THE PROPOSED A122 (LOWER THAMES CROSSING) DEVELOPMENT CONSENT ORDER

Comments on Applicant's submissions at Deadline 4 and responses to ExA Action Points submitted on behalf of the Port of London Authority

PINS Reference Number	TR010032
Interested Party Reference Number	20035622
Document Ref.	PLA 12
Author	Winckworth Sherwood LLP
Date	3 October 2023

Figure 1.1 – location plan

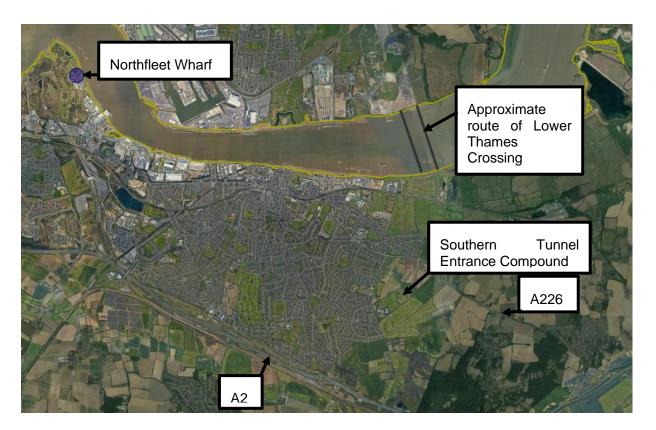
1.7 The sequence of images below shows how material from the wharf can be transported to the Southern Tunnel Entrance Compound, exiting the wharf onto Thames Way and then travelling past Ebbsfleet International Station on the A2260 onto the A2 and to the Southern Tunnel Entrance Compound via the internal road referred to in the outline materials handling plan as "Construction Routes – Offline – Main." The oMHP has identified in Annex B.1. Table B.1.1 that the site (reference 13AS) is 8.5 miles (25 minutes) from Compound A and 12 miles (30 minutes) from Compound B South. The PLA questions how these figures have been arrived at with a simple check on a route planner showing the distance and time would be less than that quoted by the Applicant: approximately 6 miles and 15 minutes from the wharf to the entrance to the compound off of the A2.
